REMARKS

Amendments to the Drawings:

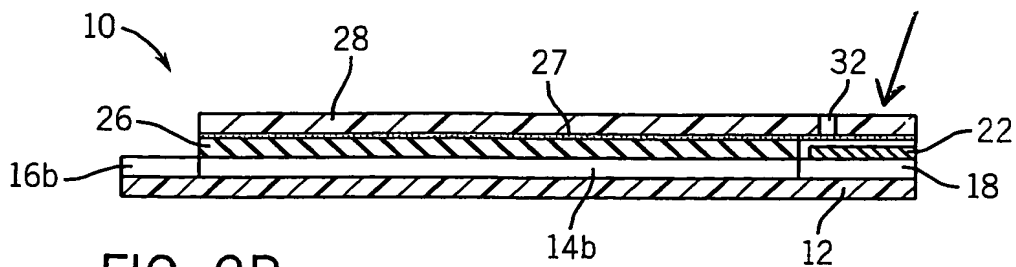
The drawings were objected to under 37 CFR 1.83(a). Corrected drawings are being submitted herewith. In addition, new drawings are also being submitted. FIG. 2 has been replaced by FIGS. 2A and 2B. These drawings clearly show the flow channel 30 is configured to provide flow of liquid by means of capillary attraction. FIG. 7, a new drawing, shows a biosensor having an electrode arrangement consisting of four electrodes, which both covers an electrode arrangement having both a reference electrode and a counter electrode and an electrode arrangement having a trigger electrode. FIG. 8, a new drawing, shows a biosensor having a layer of mesh for promoting flow of liquid to the electrodes.

The attached sheets of drawings include deletion of FIG. 2 and substitution of FIG. 2 by FIG. 2A and FIG. 2B. In FIG. 2A and FIG. 2B, the capillary channel is shown more clearly by means of a dashed line in FIG. 2A and a section in FIG. 2B. The attached sheets of drawings include addition of FIG. 7 and FIG. 8. In FIG. 7, a trigger electrode 40 has been added, and the dual - purpose reference/counter electrode has been replaced by a separate reference electrode 36 and a separate counter electrode 34. The working electrode has been numbered as 38. In addition conductive tracks 14c, 14d, 14e, and 14f and electrical contacts 16c, 16d, 16e, and 16f have been added and numbered. In FIG. 8, a layer of mesh 40' has been added between the two substrates 12a' and 12b' and in the vicinity of the electrodes 18' and 20'.

Markings added to show
capillary flow channel
